ARKANSAS NUCLEAR ONE - UNIT NO.1

AMENDMENT TO FACILITY OPERATING LICENSE

Amendment No. 64
License No. DPR-51

SAFETY EVALUATION BY THE OFFICE OF NUCLEAR REACTOR REGULATION

FIGURE 6.2-2 FUNCTIONAL ORGANIZATION FOR PLANT OPERATION

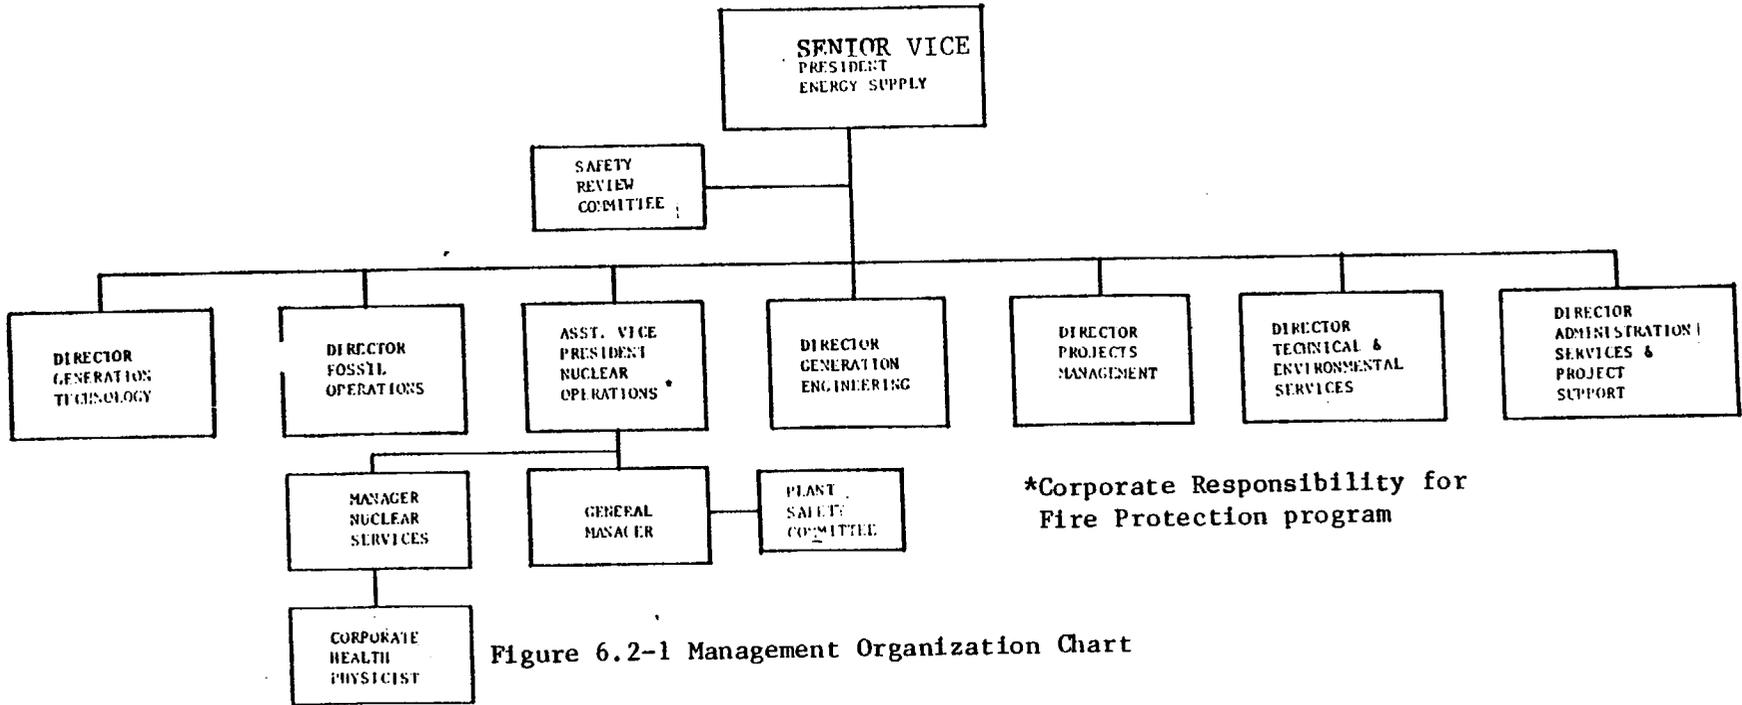
The proposed change consists of elevating the plant Health Physics Section to a level comparable with Operations and Maintenance groups, changing the title of the plant Health Physics Supervisor to Health Physics Superintendent, and establishing the position of Corporate Health Physicist to provide a direct interface with the Health Physics Superintendent. The licensee also proposed to replace the reference to "Special Work Permit" with the words "Radiation Work Permit" in Section 6-11, "High Radiation Area," of the TSs. This is a change in terminology only; no controls are changed.

- (1) The Health Physics Superintendent reports to the Manager, Engineering and Technical Support in administrative matters and routine health physics concerns and he reports to the General Manager in matters of radiological health, safety and policy.
- (2) The Health Physics Superintendent has direct interface with the Corporate Health Physicist in matters of radiological health and safety. The Corporate Health Physicist reports to the Manager, Nuclear Services. He will help formulate Corporate Health Physics Policy and ensure that it is properly implemented.
